Access Compliance Report

Public Rights-of-Way

(Curb Ramps)

Intersection ID: 14505	Main Street: REMOUNT_RD	Cross Street: REMUS_RD	Location: NE
ADA ID: 7188186B0C36	Ramp Type: PerpDiag	Initial Pass/Fail: Fail	Overall Compliance: No
Severity Score: 35			
Codes/Mitigation Info/Possible Solution		Field Measurements/Component Compliance

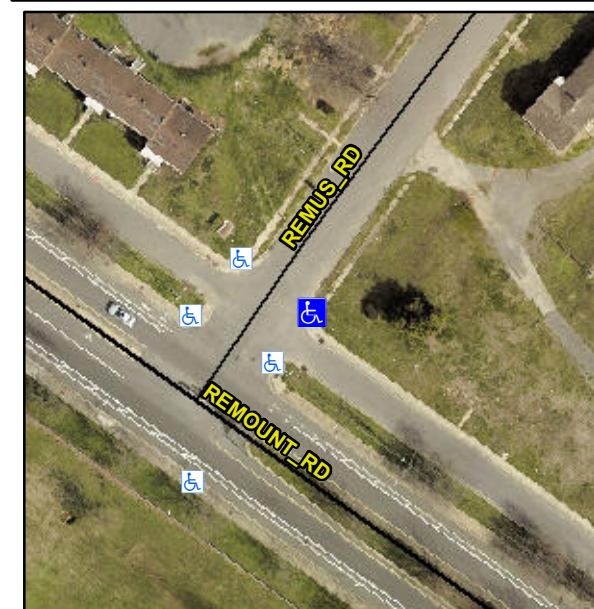
Not Found, R304.5.1

Compliance	Description	Data	Compliance	Description	Data
N/A	Ramp Length (in)	64.0	Yes	Ramp Slope (%)	6.7
No	Ramp Width (in)	25.0	Yes	Ramp XSlope (%)	0.1
N/A	Flare Type LT	N/A	N/A	Flare Type RT	N/A
N/A	Flare Slope LT (%)	N/A	N/A	Flare Slope RT (%)	N/A
N/A	Flare Traversable LT?	N/A	N/A	Flare Traversable RT?	N/A
N/A	Landing Length (in)	N/A	N/A	DWS Provided?	N/A
N/A	Landing Width (in)	N/A	N/A	DWS Contrast?	N/A
N/A	Landing Slope (%)	N/A	N/A	DWS Length (in)	N/A
N/A	Landing X Slope (%)	N/A	N/A	DWS Full Width?	N/A
N/A	Landing Curb? (Y/N)	N/A	N/A	DWS Offset (in)	N/A
N/A	Shared Landing?	N/A			
N/A	Gutter Ponding?	N/A	N/A	Gutter Slope (%)	N/A
N/A	Gutter Lip Ht (in)	N/A	N/A	Gutter X Slope (%)	N/A
N/A	Painted X Walk1?	No	N/A	Painted X Walk2?	No
	X Walk 1 Direction	To NW		X Walk 2 Direction	To SW
N/A	X Walk 1 Width (in)	N/A	N/A	X Walk 2 Width (in)	N/A
	X Walk 1 Slope (%)	0.7		X Walk 2 Slope (%)	0.3
	X Walk 1 X Slope (%)	0.7		X Walk 2 X Slope (%)	0.6

Remove & Replace Curb Ramp With Two New Directional Ramps or Equivalent.
